Ad Hoc Committee Agenda Item #:	II A – Action Item
Date:	December 4, 2019
To:	Magnolia Educational & Research Foundation dba Magnolia Public Schools (“ MPS ”) Ad Hoc Committee (the “ Committee ”)
From:	Alfredo Rubalcava, CEO & Superintendent
Staff Lead:	Patrick Ontiveros, General Counsel & Director of Facilities
RE:	MSA-1 Change Order Requests

COR/PCI	DESCRIPTION	COMMENTS / EXPLANATION	COST
42	Extended General Conditions Reconciliation	<p>Change order request includes costs associated with the extension of general conditions from the previously reconciled substantial completion date of July 2, 2019 to the actual substantial completion date of September 18, 2019. The project dates were impacted due to the delay in the release of power by DWP--the meter was energized on August 26, 2019--and the release of LADBS sign offs allowing for occupancy.</p> <p>Includes a credit for the non-installation of the Proto II wall. The City of LA would not issue a permit for its construction without a lot tie. A lot tie was only feasible following approval of the zone change.</p> <p>General conditions are the contractor's direct costs and overhead.</p>	\$60,364.82
43	Electrical Added Scope to existi

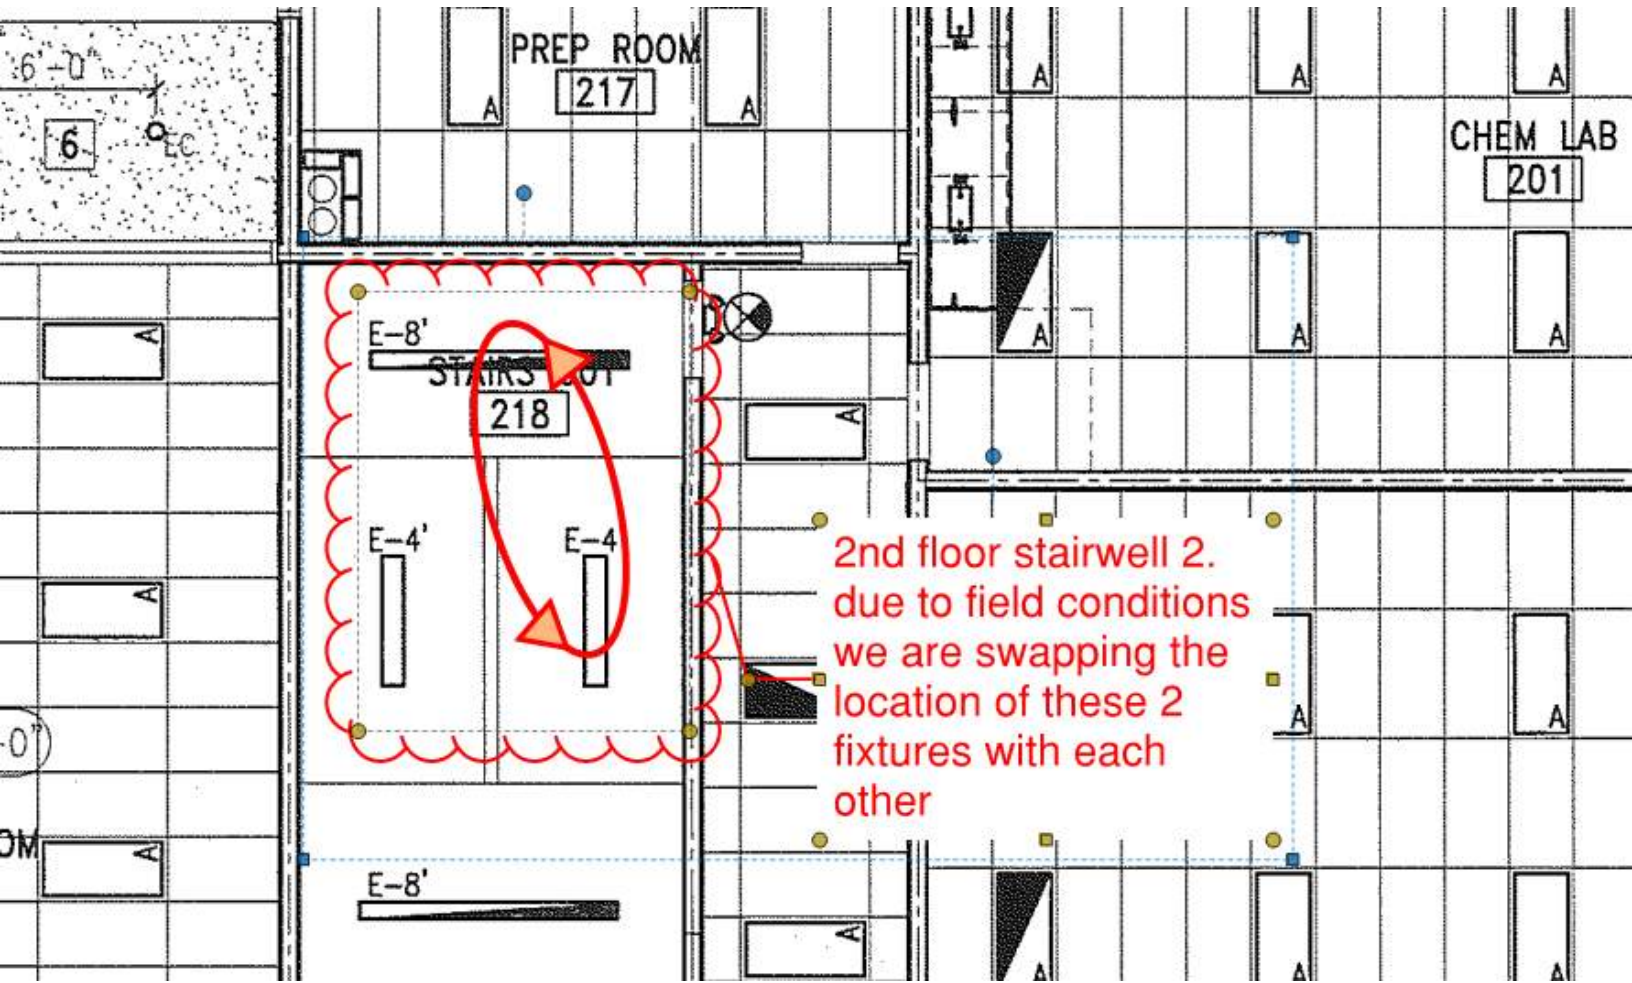
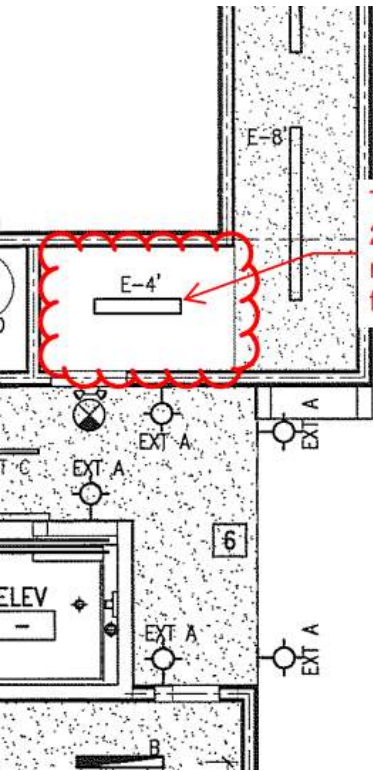
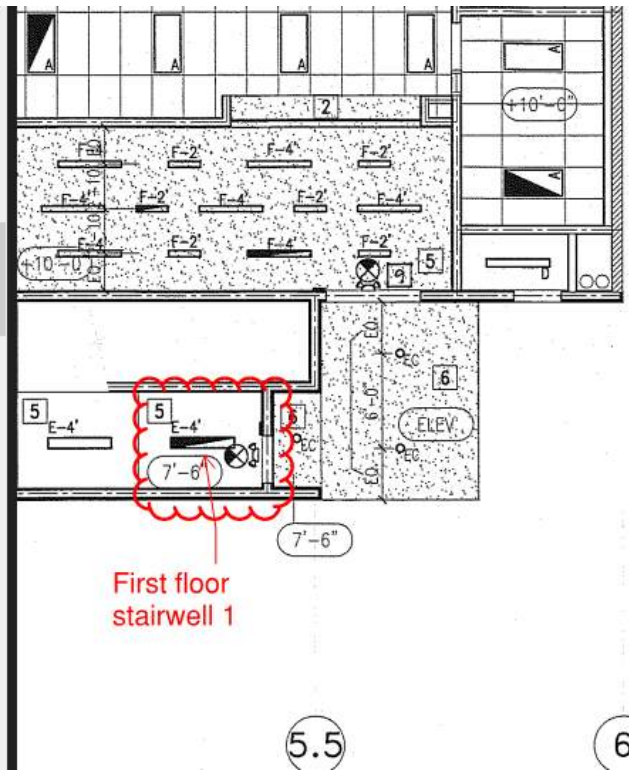
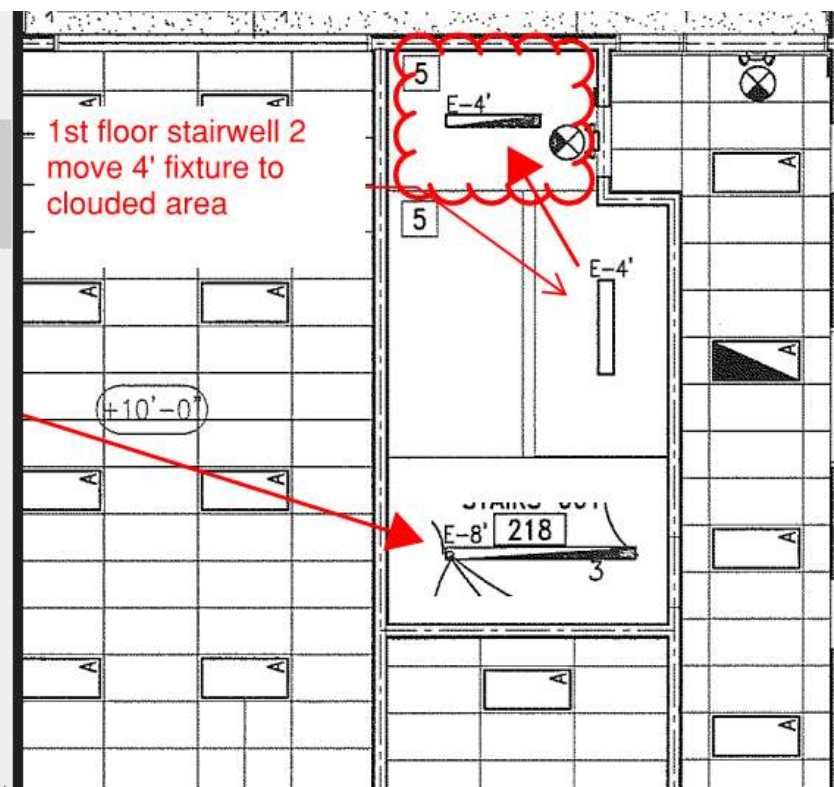
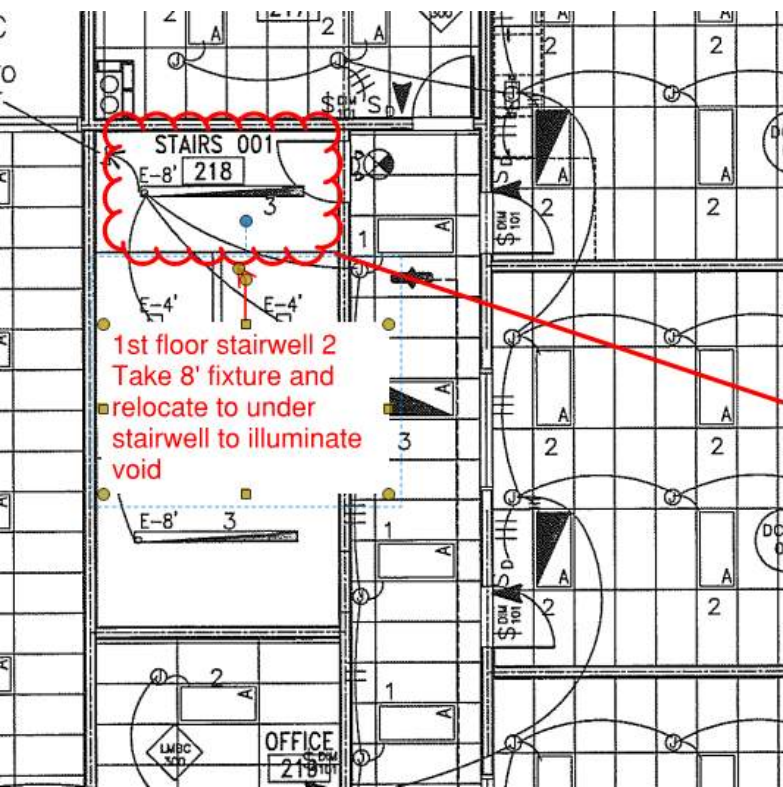
Please provide mounting clarification for the E4 fixtures in the stairwells (sheets E3.1 & E3.2). The prints show the fixtures to be mounted on the underside of the steel stairs. Attached is a photo showing the field conditions that are typical for both stairwells. In the photo you can see the all Steel Stairs are surrounded by Beams and Gluelams.

This 3rd floor stairwell
2 - 4' fixture will
relocate to the 1st
floor stairwell 1

SUBJECT: Top Plate CMST12 Strap
PROJECT: Magnolia Science Academy

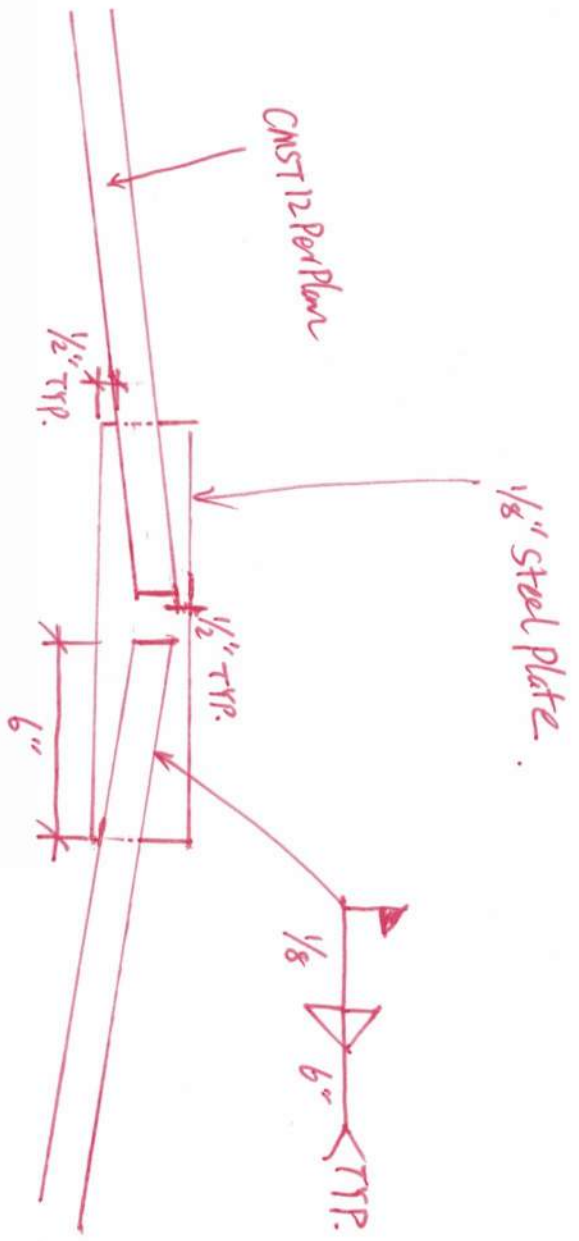
Sheet S 7.1 detail 6 calls out for a CSMT 12 strap, see attachment, this strap cannot be installed on the side of the top plate due to the required roof pitch. The strap cannot be bent to match the pitch. Please advise.

Splice at the strap turning point with 1/8" steel plate with 1/8" x 6" long welding at top and bottom of each strap end.
Please see the attached sketch.
